Staff Report & Recommendation

Historic Preservation Board

SUBJECT: HPB25-0656, **1600 Washington Avenue**

An application has been filed requesting a Certificate of Appropriateness for the total demolition of two structures and the construction of a new mixed-use building.

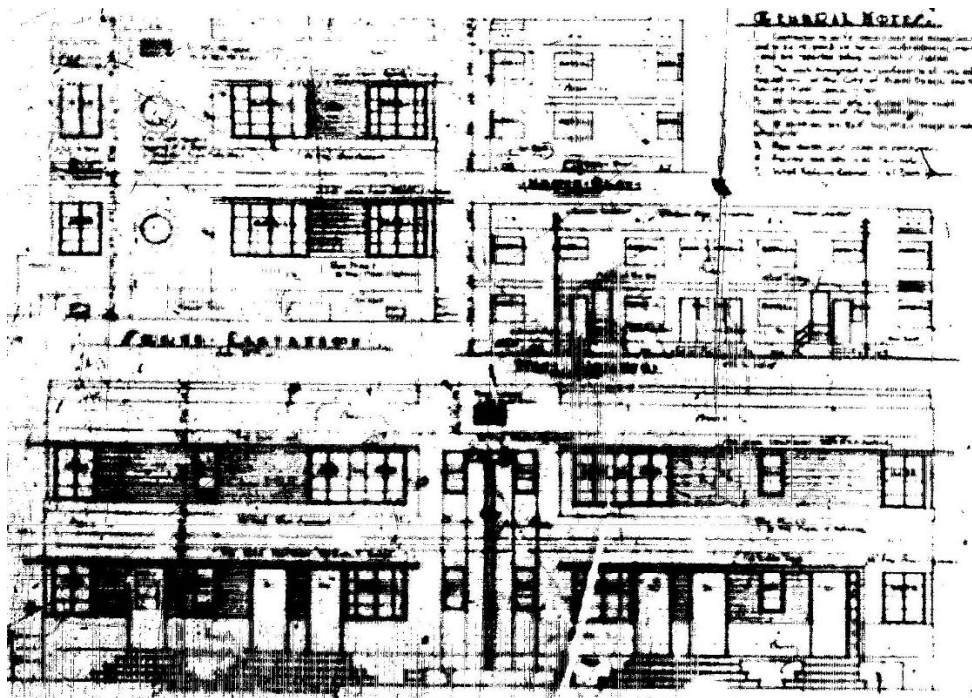
The project includes the total demolition of the existing 1-story Non-Contributing building located at 1600 Washington Avenue as well as the total demolition of the existing 2-story Contributing building and the construction of a new 15-story ground level addition containing 210 residential units and approximately 7,000 SF of retail space on the ground floor. The existing parking garage will be retained and incorporated into the new mixed-use development.
